ORIGINATION FORM

Proposed Revisions to a Standard Plans Index (Please provide all information — Incomplete forms will be returned)

Index Number: 700-020

Index Title: Multi-Column Ground Sign

SHEET
1 of 3

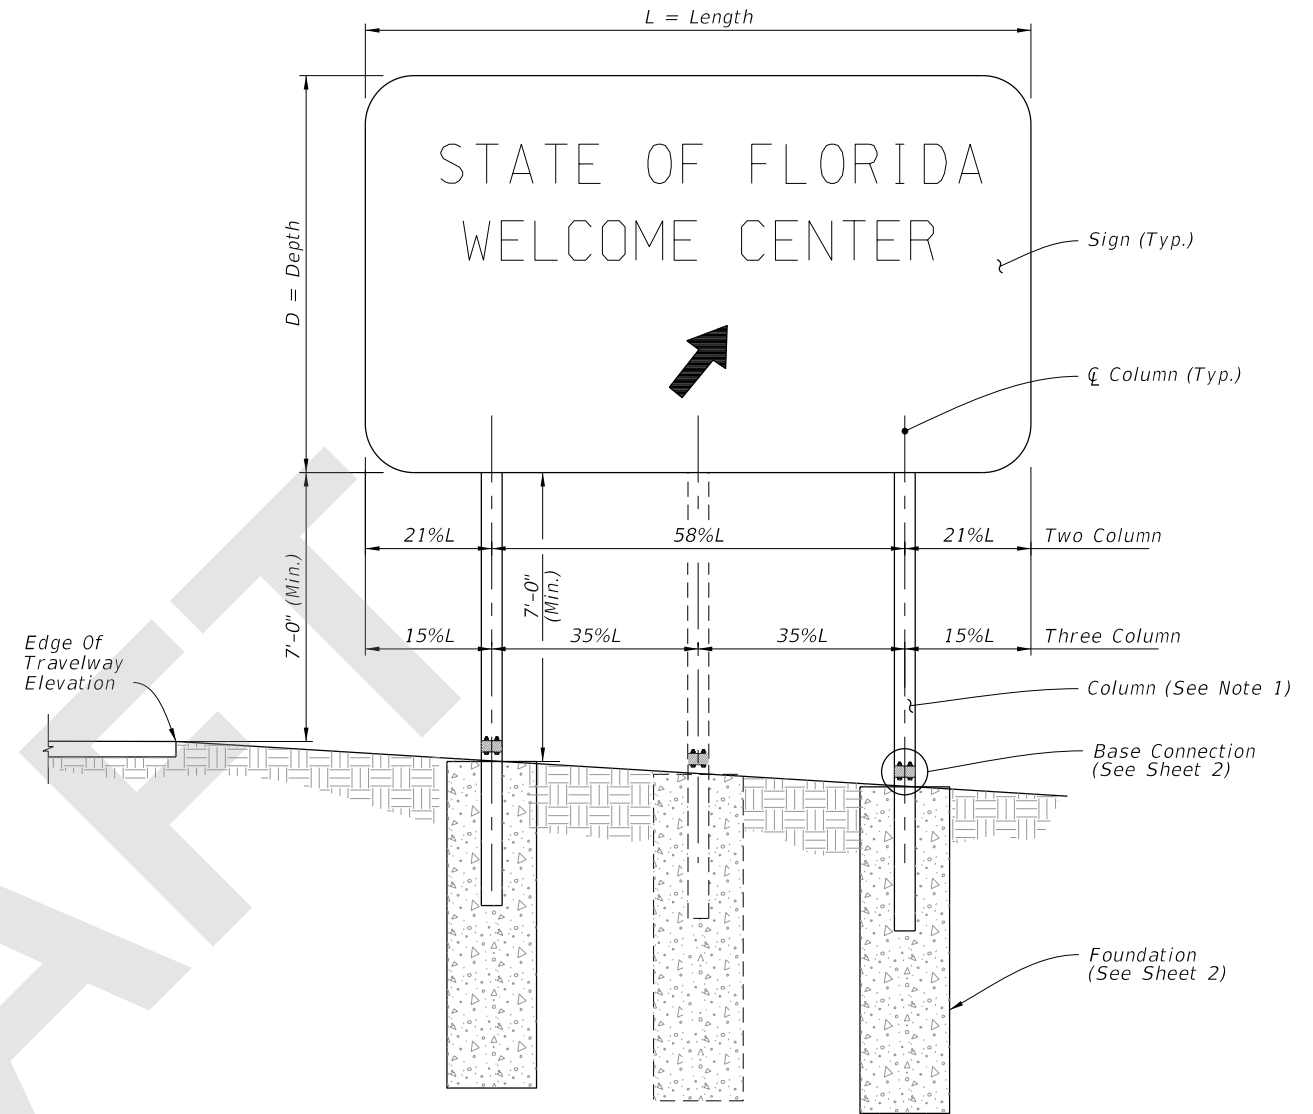
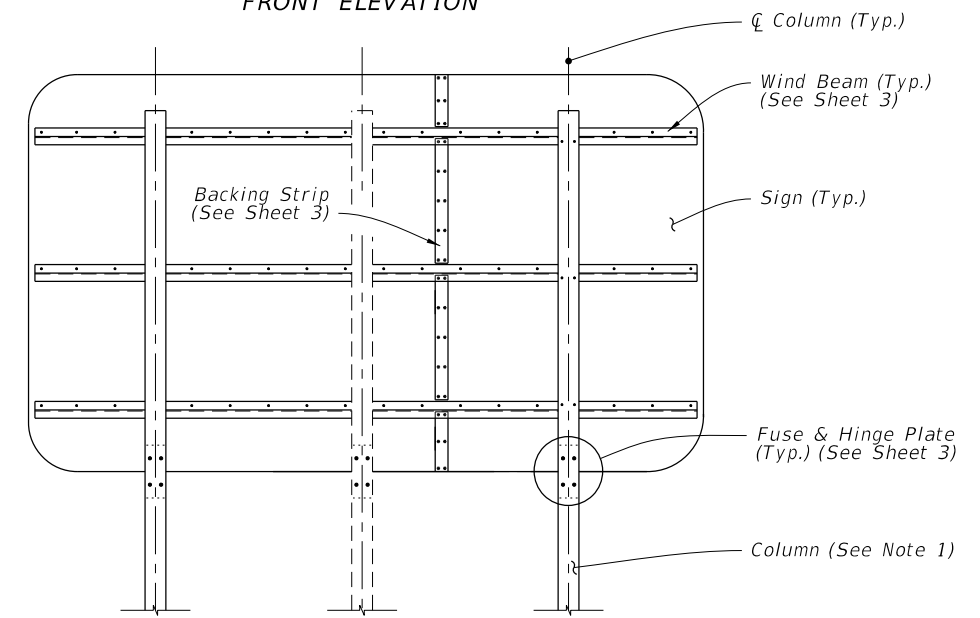
Sheet 1: Change Note 3.A.b reference to ASTM B308 to ASTM B221 throughout Standard Plans as an administrative change.

ASTM withdrew B308-10 so we need to change it to ASTM B221

- b. Aluminum Structural Shapes: ASTM B308, Alloy 6061-T6
 - B. Sign Support Structure Materials:
 - a. Steel Plates and Structural Shapes: ASTM A36 or ASTM A709, Grade 36

- b. Aluminum Structural Shapes: ASTM B221, Alloy 6061-T6
 - B. Sign Support Structure Materials:
 - a. Steel Plates and Structural Shapes: ASTM A36 or ASTM A709, Grade 36
